Access Compliance Report Public Rights-of-Way (Curb Ramps)

Main Street: PERCHERON_DR Cross Street: DE_LEON_LN Location: W

ADA ID: RPRK211112143402 Ramp Type: Type 4 - Parallel Initial Pass/Fail: Fail Overall Compliance: No Severity Score: 2

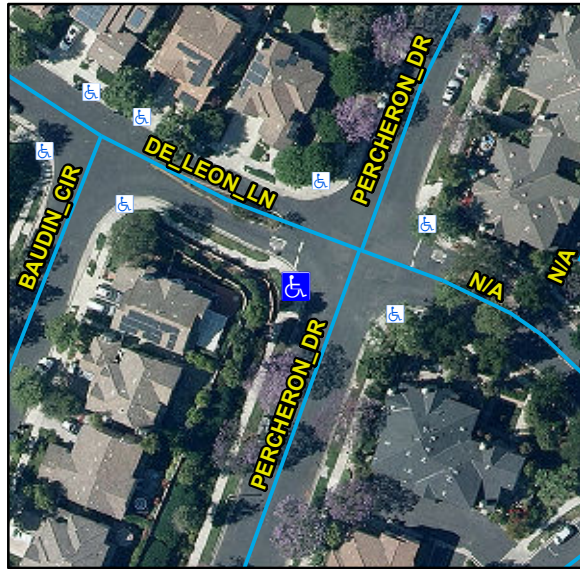
R304.2.2, R204.3, R304.5.3, STD 1115

Compliance	Description	Data	Compliance	Description	Data
N/A	Ramp Length LT (in)	130	N/A	Ramp Length RT (in)	125
Yes	Ramp Width LT (in)	50	Yes	Ramp Width RT (in)	50
Yes	Ramp Run Slope LT (%)	4.2	Yes	Ramp Run Slope RT (%)	3.7
No	Ramp Cross Slope LT (%)	2.6	Yes	Ramp Cross Slope RT (%)	1
N/A	Landing Present	N/A	N/A	DWS Provided	N/A
N/A	Landing Length (in)	N/A	N/A	DWS Contrast	N/A
N/A	Landing Width (in)	N/A	N/A	DWS Length (in)	N/A
N/A	Landing Run Slope (%)	N/A	N/A	DWS Full Width	N/A
N/A	Landing Cross Slope (%)	N/A		DWS Offset Type	N/A
N/A	Landing Movement Obstructed?	N/A	N/A	DWS Offset Left (in)	N/A
	Landing Movement Type	N/A	N/A	DWS Offset Right (in)	N/A
N/A	Landing Shared	N/A			
N/A	Clear Space	Yes			
N/A	Clear Space To Crosswalk (in)	N/A			
N/A	Marked Crosswalk 1	No	N/A	Marked Crosswalk 2	No
	Crossing 1 Direction	SE		Crossing 2 Direction	NE
N/A	Marked Crosswalk 1 Width (in)	N/A		Marked Crosswalk 2 Width (in)	N/A

Remove & Replace Curb Ramp With Two New Directional Ramps or Equivalent.
